RE: JMC Project 20101
The Summit Club at Armonk Residential
Bedford Road (Route 22)
Town of North Castle, NY

Response to Town Comments Resubmission

Town of North Castle Planning Department, dated April 4, 2022

DRAWING NO.
LS102.1

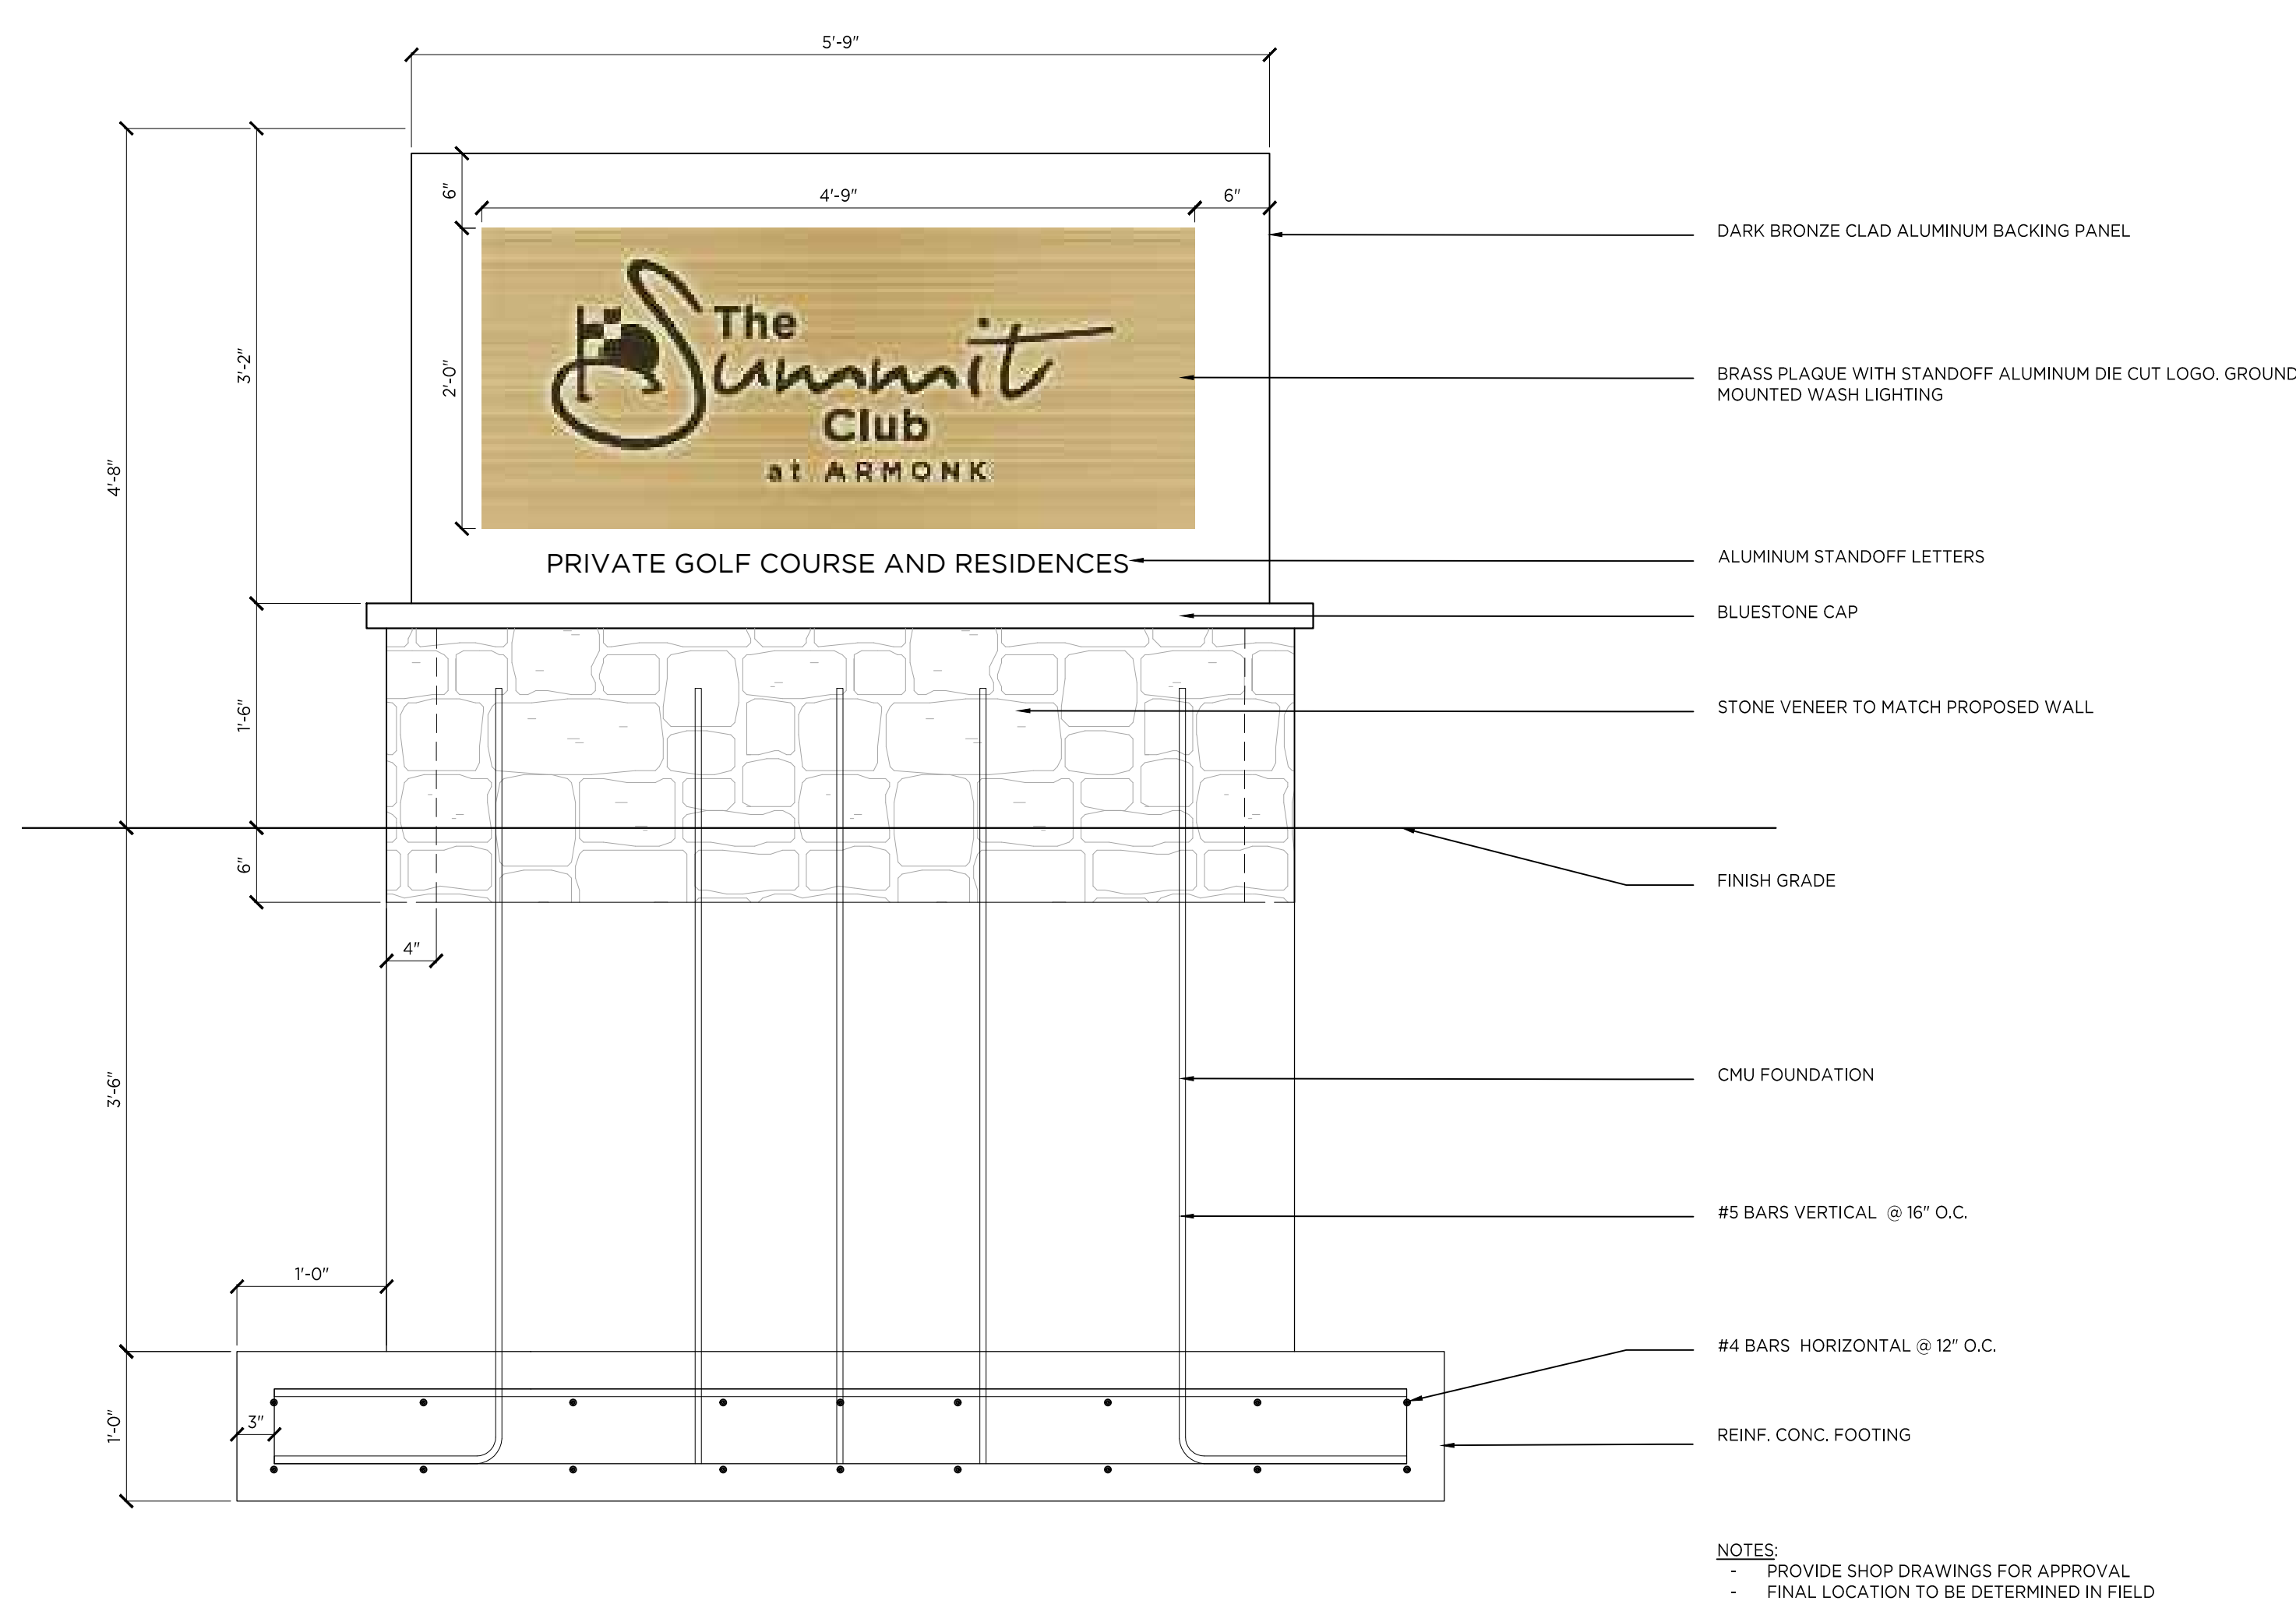
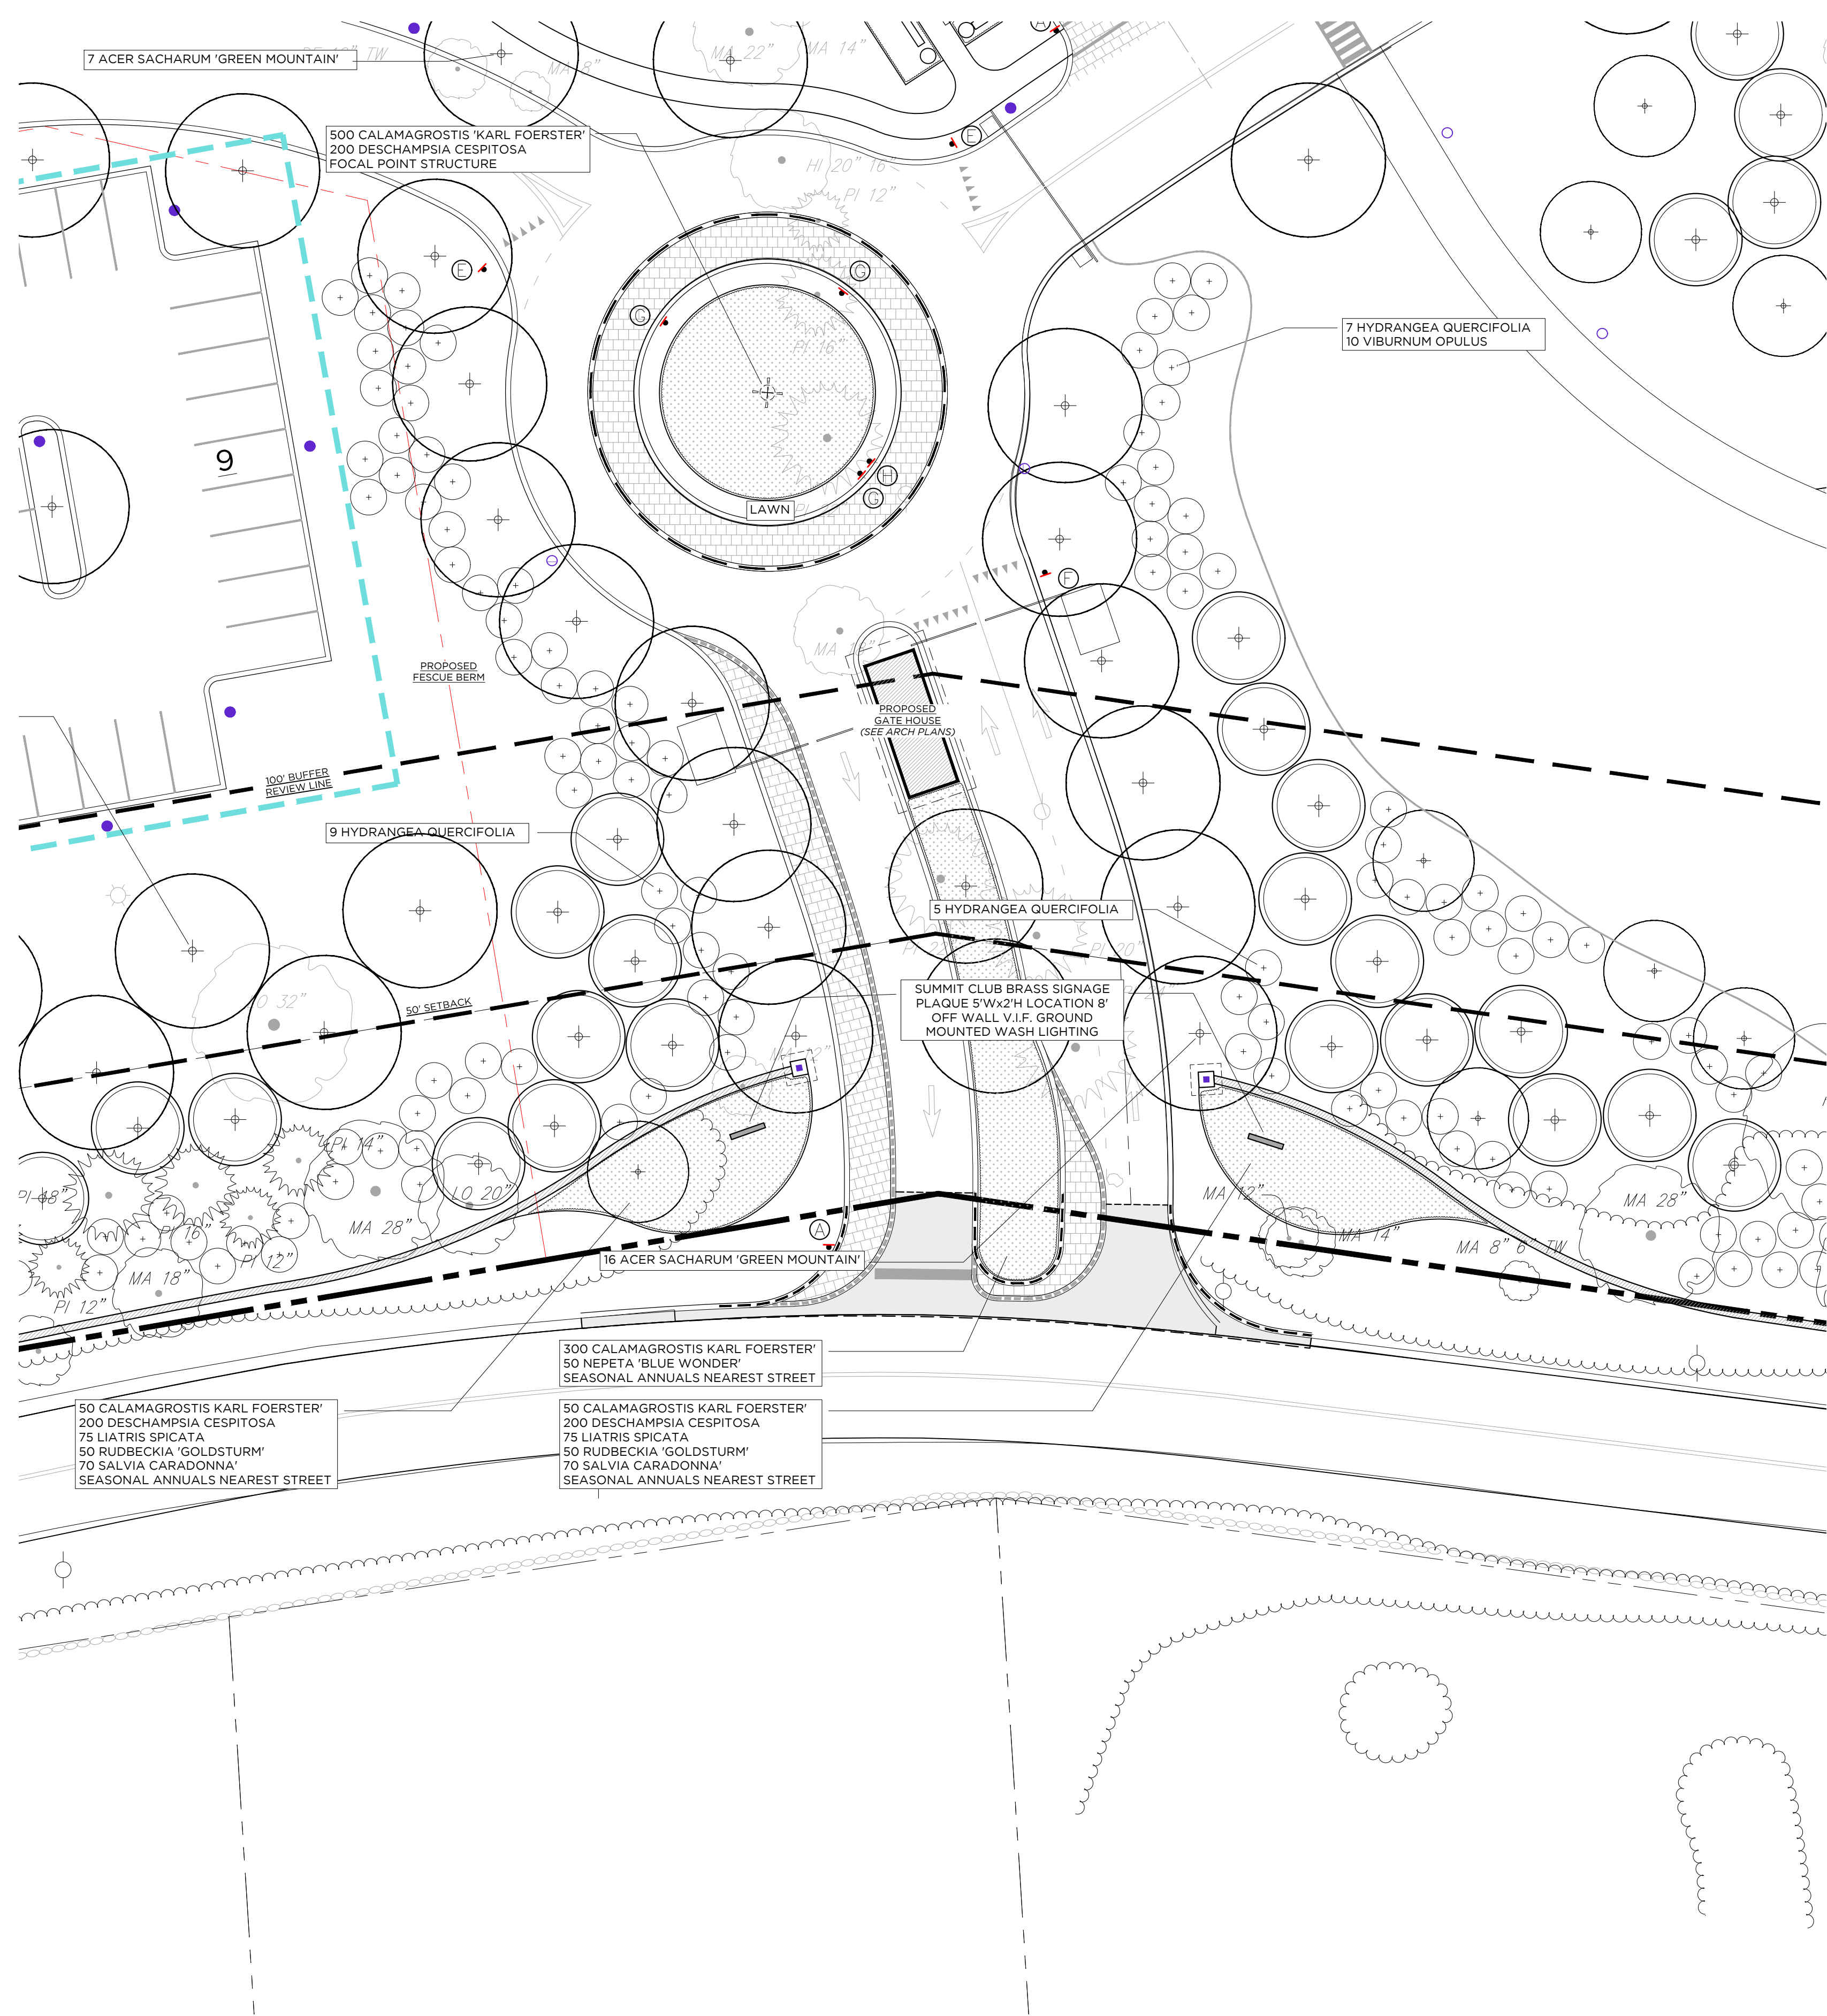
Comment No. 14

The Applicant has stated that signage is proposed for the project. The location and design of the signage should be included on the plans at this time.

Response No. 14

New entrance signage will be proposed on the new decorative stone walls proposed at the entrance to the site. Additional signage will be provided throughout the interior of the development area as required (traffic control, directional, etc.). The design of the proposed entrance signage will be prepared and provided under separate cover. Refer to drawing LS 102.1, prepared by Granoff Architects for Entry Signage detail.

DRAWING NO.
A-100.A

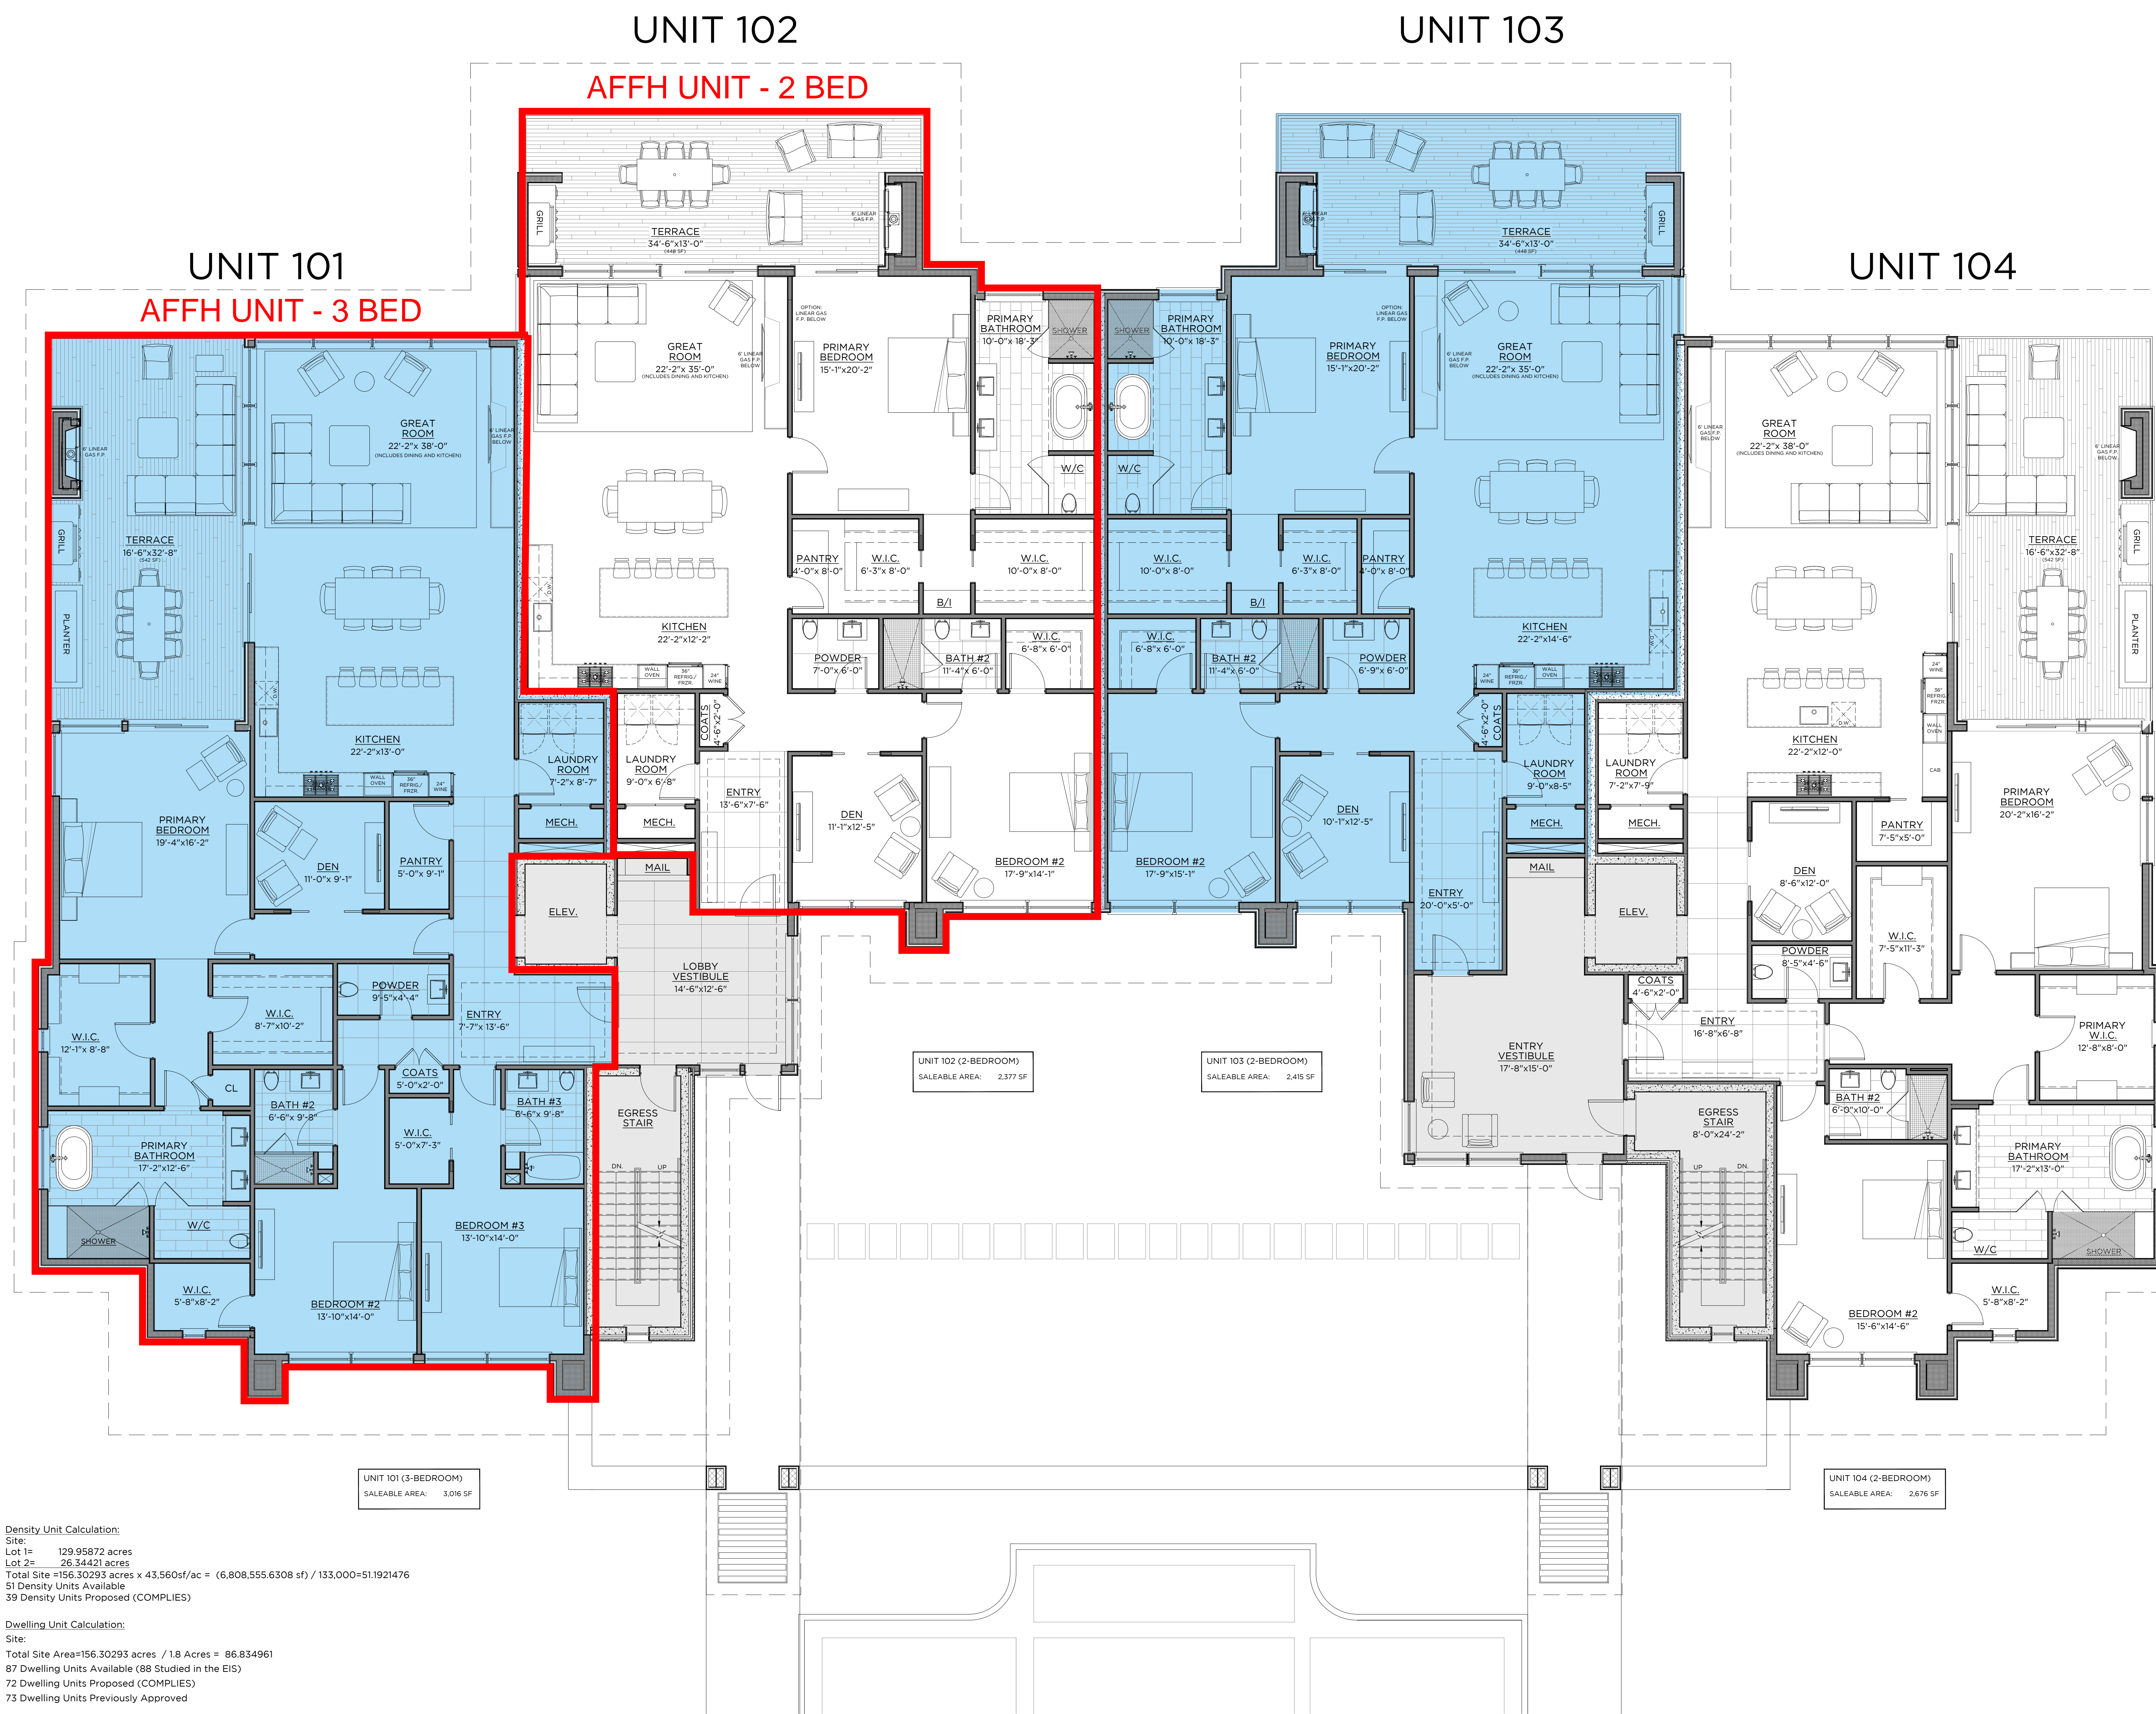
Comment No. 3

The floor plans should be revised to depict which seven of the 72 units will be designated as AFFH units.

Response No. 3

Granoff Architects has re-submitted the floor plans and highlighted the chart and units that are planned to be AFFH units.
